OSSF Inspection Sheet

Permit of Authorization to Construct an On-Site Sewage Facility Permit Valid For One Year From Date Issued

Permit Number: 118025
Issued This Date: 11/12/2024
This permit is hereby given to: Brant Shalek

1056 KINGS COVE DR
CANYON LAKE, TX 78133

BRANT SHALEK
1056 KINGS COVE
CANYON LAKE, TX 78133
KINGS COVE UNIT 1
LOT 35, BLOCK 2
COMAL COUNTY

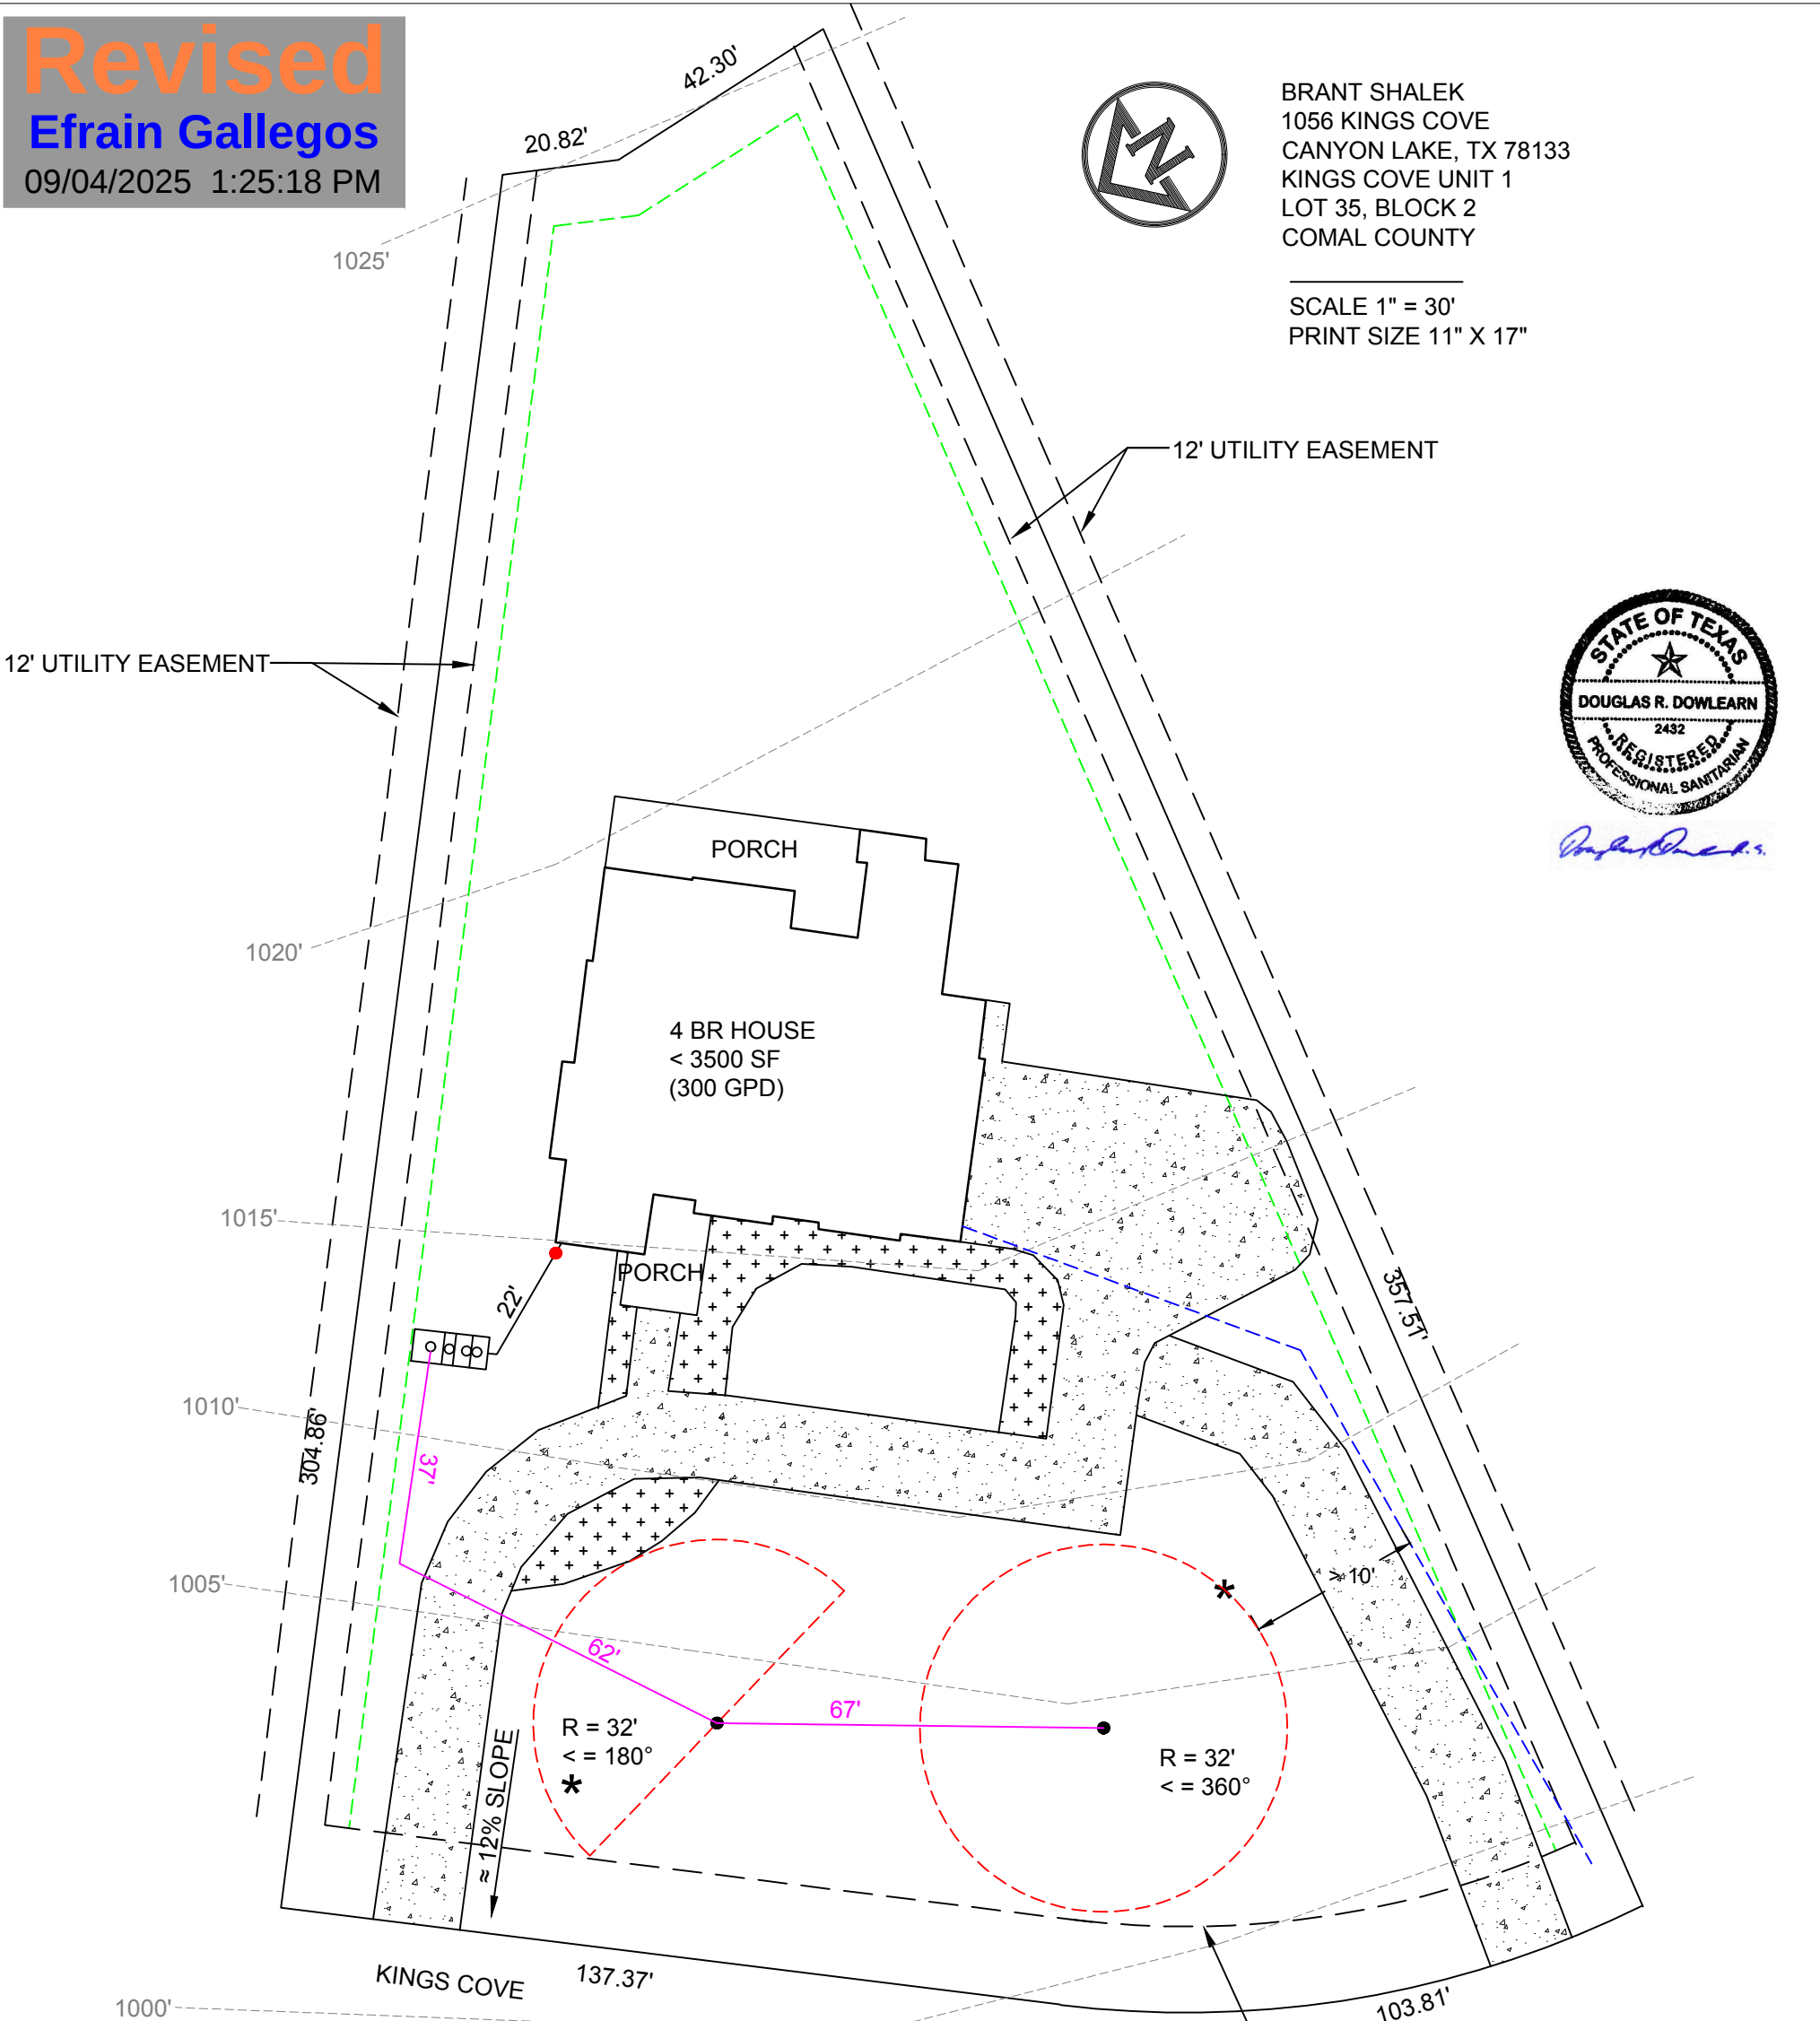
I am requesting a variance for the placement of a spray disposal area 10 feet from the property line, but less than 20 feet from the property line as Comal County regulations require. This variance is requested due to limited space. This setback complies with TCEQ CHAPTER 285 rules Table X. requirements. Equivalent protection will be maintained by including a battery backup to the timer clock to assure sprayers only spray during the predawn hours. In my professional opinion this variance will not pose a threat to the environment or public health.

- ✓. Maintain required 20 ft. setback from the edge of the spray areas to the property lines.
2. Revise as needed and resubmit.
